**Errata for the PCI-X Electrical and Mechanical
Addendum, Revision 2.0a**

Rev B.5

12/10/03

Figure 2-19: PCI-X 266 End of Data Strokes, Three Data Phases

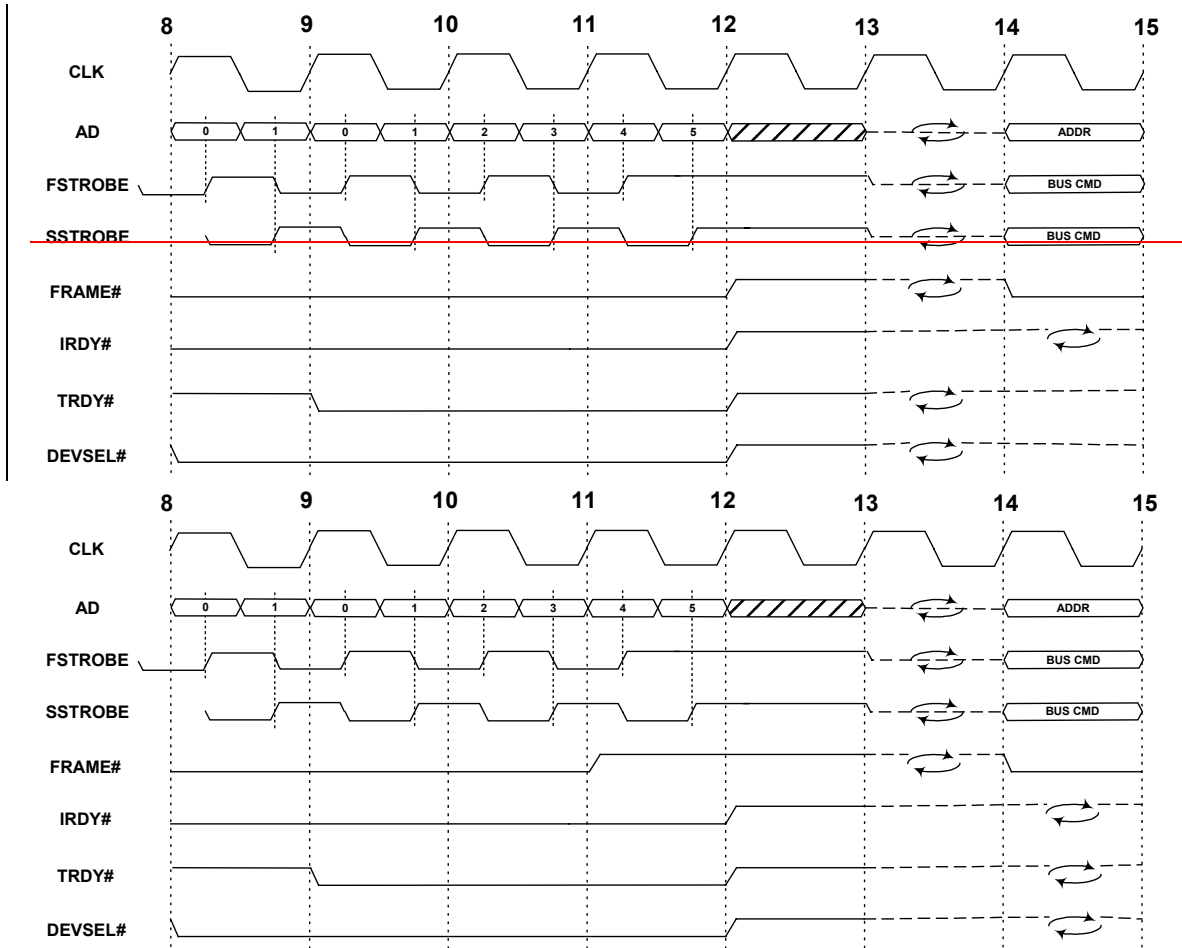
1. Figure 2-19, page 43, and Figure 2-23, page 45, include protocol errors inconsistent with the requirements of PCI-X PT 2.0a. Each figure shows a three-data-phase transaction, but FRAME# is shown deasserting after the third data phase, when in fact, FRAME# should be shown deasserting on the third data phase, as correctly shown in Figure 2-68 in PCI-X PT 2.0a.

Furthermore, Figures 2-19, 2-20, 2-21, 2-23, 2-24, 2-25 all show turn-around of the target control

signals on a different clock than the one typically shown in PCI-X PT 2.0a. This is strictly an issue of documentation convention, since the target control signals are floating for several clocks, and the precise timing of the turn-around is artificial.
